UNITED STATES PATENT AND TRADEMARK OFFICE

10/595,149

NEISE, RALF

DETAILED ACTION

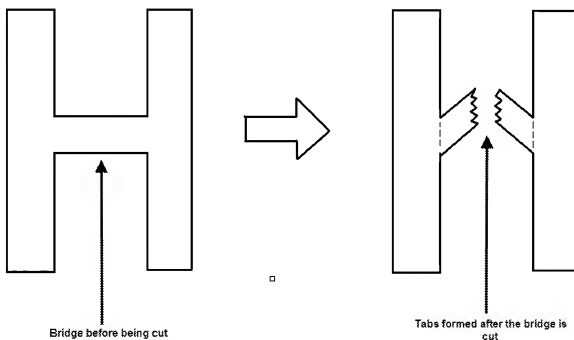
9. In Re claim 2, Zdanys, Jr. et al ('407) further discloses the electrical conductor tracks comprise a perforation comb, and individual conductor tracks are connected via bridges, wherein each connection can be severed through a stamping process after the perforation comb has been placed in the housing. The examiner notes that the perforation comb is disclosed by figure 7 as best understood by the examiner.

13. In Re claim 8, Zdanys, Jr. et al ('407) further discloses wherein the electrical conductor tracks are fixed with positive engagement in the area of respective ends of the electrical conductor tracks and corresponding bridges (74). See figure 7.

14. In Re claim 9, Zdanys, Jr. et al ('407) , with reference to figure 7, discloses tabs for crimping to promote positive engagement by passing said tabs through a recess in a substrate and also to separate the bridges in order to prevent a short. The examiner notes that by cutting the bridges down the center, the bridge would necessarily deform during this process, during which a tabular feature would then be formed which could be used in a known manner, such as previously mentioned, in which case the bridge would then be able to also provide positive engagement to the housing. See also the figure below.
